FIXED BEAM ANCHOR - INSPECTION NOTICE (FOR SALT-WATER/CHLORIDE/SULFIDE ENVIRONMENTS)

The DBI-SALA Fixed Beam Anchor is an anchorage connector for a personal fall arrest system. It is designed to be attached to an I-beam. Capital Safety's user manual warns about "Environmental Hazards" and that certain chemicals and corrosive environments may damage the equipment.

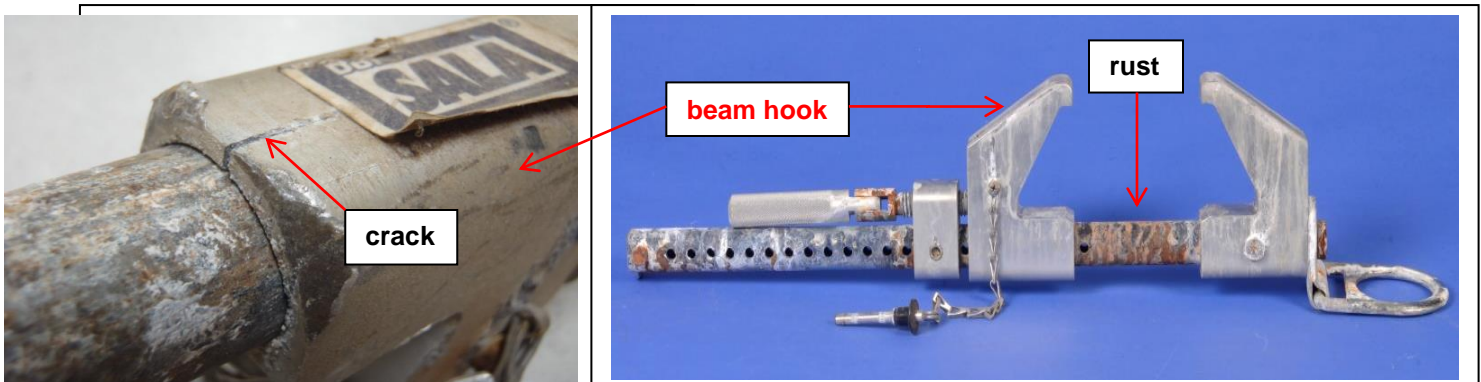
Capital Safety has become aware that the service life of the beam hooks identified in the images below (in red font) may be impaired by stress corrosion cracking when the anchor is exposed to salt-water or other chloride or sulfide-containing environments.

- 1) have the units visually inspected by a competent person; and
- 2) if **any** corrosion, pitting or cracking is found on the beam hooks or the support tube (see illustrations below), remove the unit from service and return via your supplier/distributor to Capital Safety for evaluation and potential replacement under warranty at Capital Safety's reasonable discretion and expense.

- 3) if **no** corrosion, pitting or cracking is found on the beam hooks or the support tube, the units are safe to remain in service provided they are inspected every 90 days and removed from service if **any** corrosion is found anywhere on the unit.

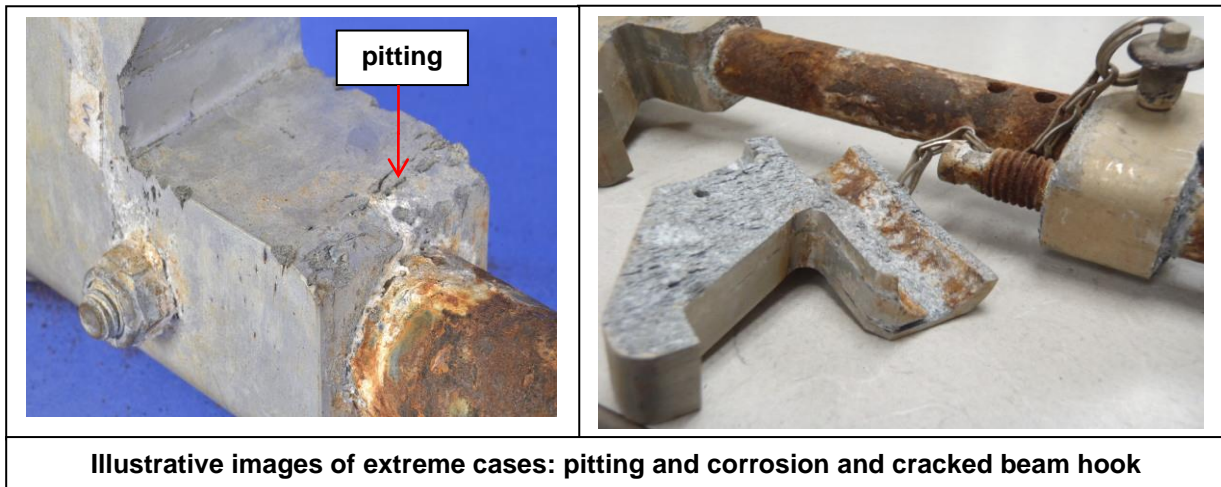
In extreme cases, the integrity of the beam hooks can be severely compromised to the point of failure by stress corrosion cracking as seen in the photographs below:

Since becoming aware of this issue, Capital Safety has changed the metal alloy of the beam hooks to make them resistant to stress corrosion cracking in salt-water or other chloride or sulfide-containing environments.

Capital Safety has also revised section 5.0 of its manual on Inspection as follows: **5.3** If inspection reveals an unsafe or defective condition remove unit from service. **IMPORTANT:** Any observed corrosion or rust on the anchor is a potential safety concern because it can weaken the product and create a risk of injury or death to workers. Any anchor showing signs of corrosion or rust should be removed from service immediately.”
